SPIRES ESTATE TOWN CENTRE

LANDSCAPE DA REPORT

**LOT 9005 NAIRN DRIVE, BALDIVIS
PROPOSED SPIRES NEIGHBOURHOOD CENTRE
RESPONSE TO CITY'S INTERNAL PLANNING COMMENTS, REFERRAL COMMENTS AND
MODIFIED PLANS**

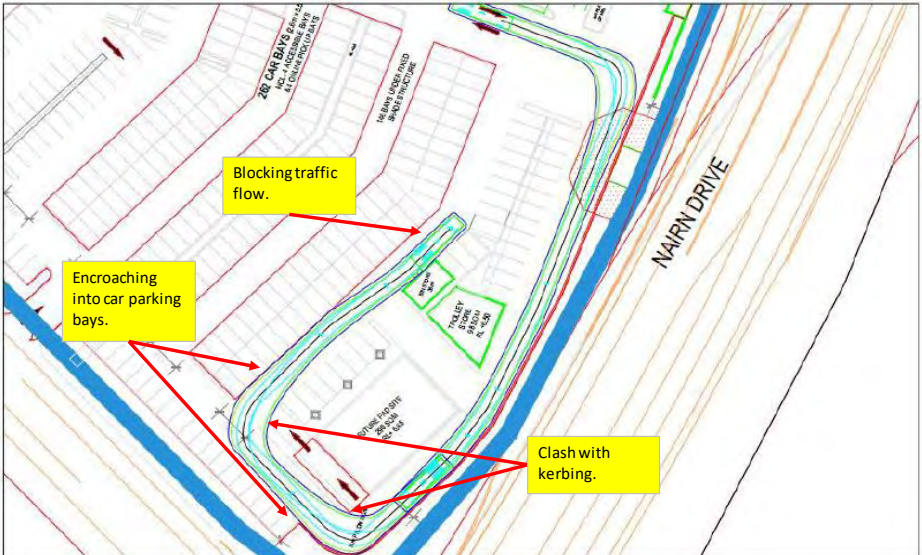
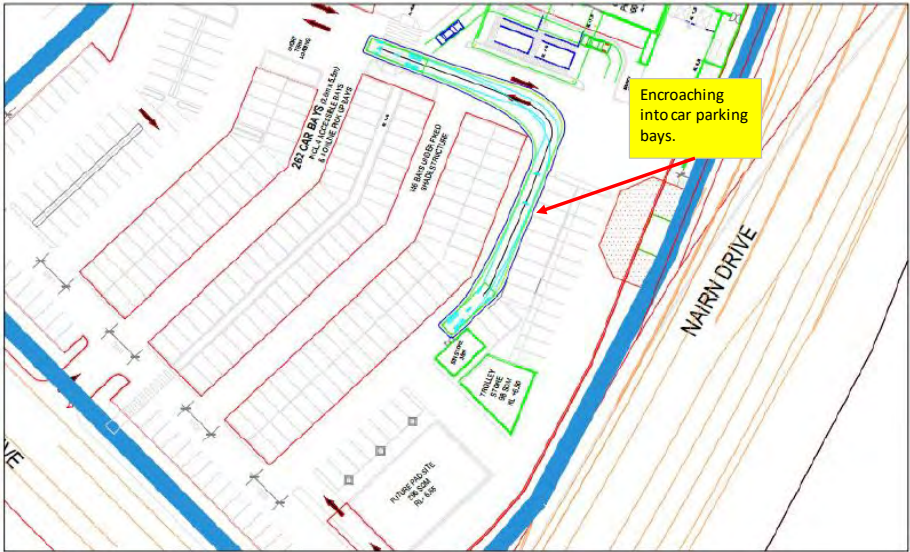
7.		The City has some concerns (i.e. encroaching into car parking bay, clash with kerbing, blocking traffic flow) regarding the provided swept path analysis in Diagram 1 and 2 within this report, which raises traffic safety concerns. Please revise swept path analysis, otherwise amend design accordingly. It should be noted that the City is unlikely to support the location of the proposed bin stores.	<p>Refer to Appendix 5 for a copy of the updated swept path diagrams.</p> <p>The updated swept path diagrams demonstrate the car parks can adequately handle waste vehicle movements. However, as detailed in Sketches sk12a to sk15a there are two parking bays still impacted by these turn paths. The proponent has agreed to</p>

No.	Sector	City Comments	Applicant Response
			<p>remove these bays two bays. The plans will be updated to reflect this in the upcoming days.</p> <p>Sketches sk18a to sk21a for the pad site bin store confirm that the parking layout around the pad site needs to be slightly adjusted to accommodate the truck turn path. The proponent has agreed to address this and update the plans accordingly.</p>

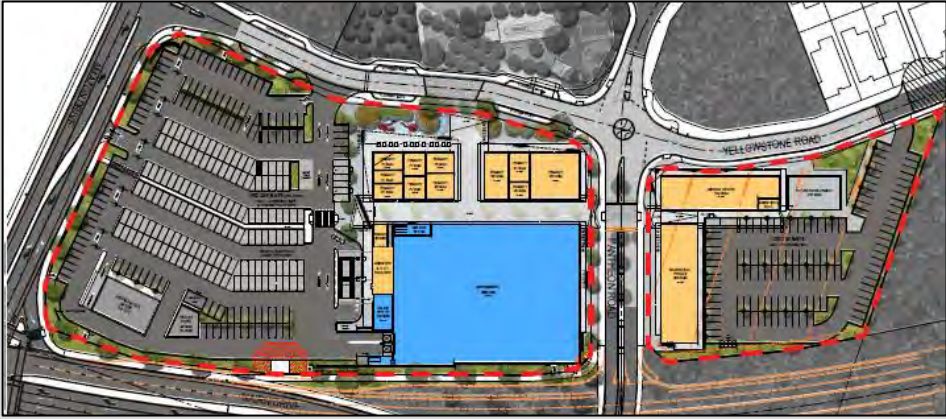
No.	Sector	City Comments	Applicant Response
		 <p><i>Snip from Landscape Masterplan – possible pathways connections.</i></p>	
39.		<p>There are a number of locations within the site which present a concern for dealing with levels and interfaces with the road reserve and maintaining universal access due to the proposed level differences.</p>	<ul style="list-style-type: none"> • The levels have been modified based on civil engineering input. Universal access will be provided throughout and can be further detailed during the detailed design stage. • The level difference of 1.0m between the proposed Shopping Centre and Recreation Centre FFL's was

Diagram 1: Waste Collection Swept Path - Entry

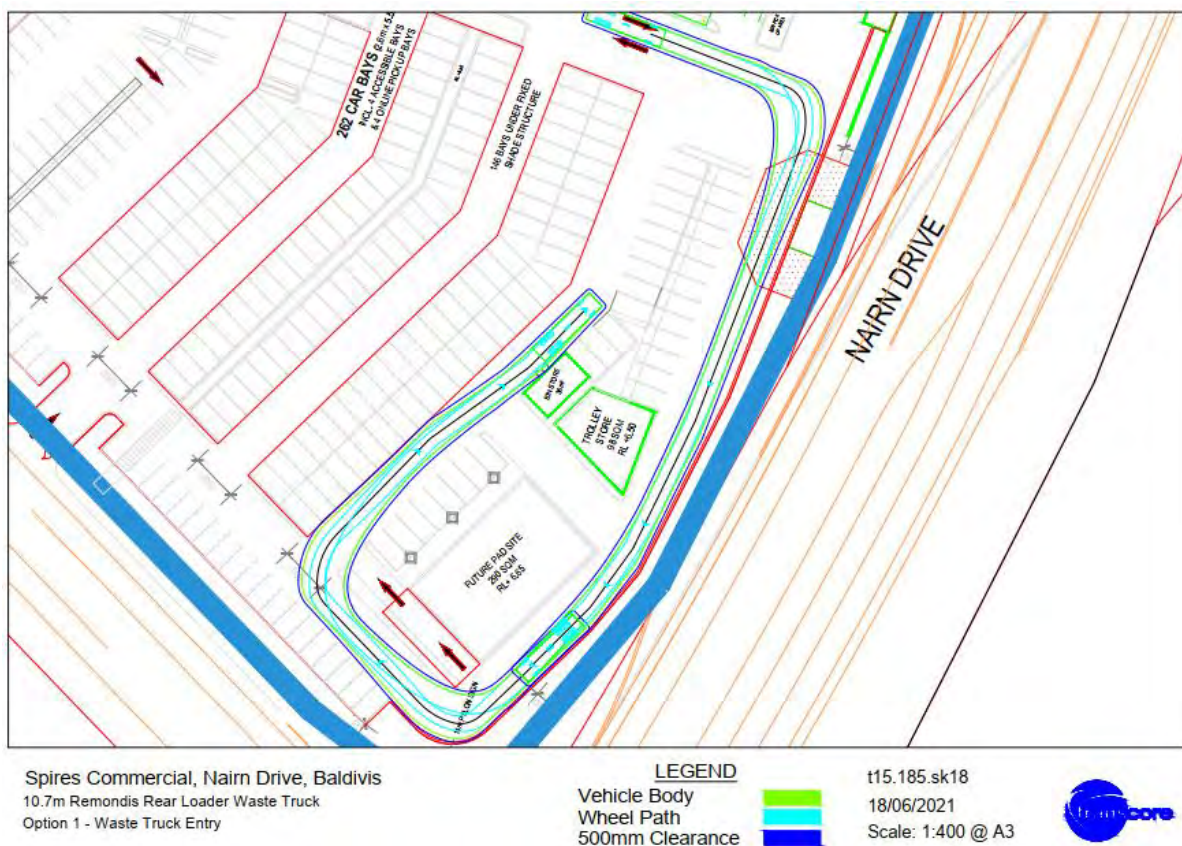
Traffic Comments			
3.	Planning Report	Section 3.1.1 mentioned that the loading bay has been designed to accommodate for a 19.5m long delivery vehicles. It should be noted that the Transport Impact Assessment instead suggests a 19.0m long semi-trailer delivery vehicles therefore there is a slight inconsistency. As discussed below,	Refer to response to item 22.

The private contractor's waste collection vehicle will service the bins onsite, directly from the respective Bin Storage Area. The private contractor's waste collection vehicle will travel with left hand lane traffic flow and turn into the Proposal in forward gear into the Proposals carpark and pull up adjacent to the Bin Storage Areas for servicing, as shown in Transcore's traffic report (refer Diagram 1).
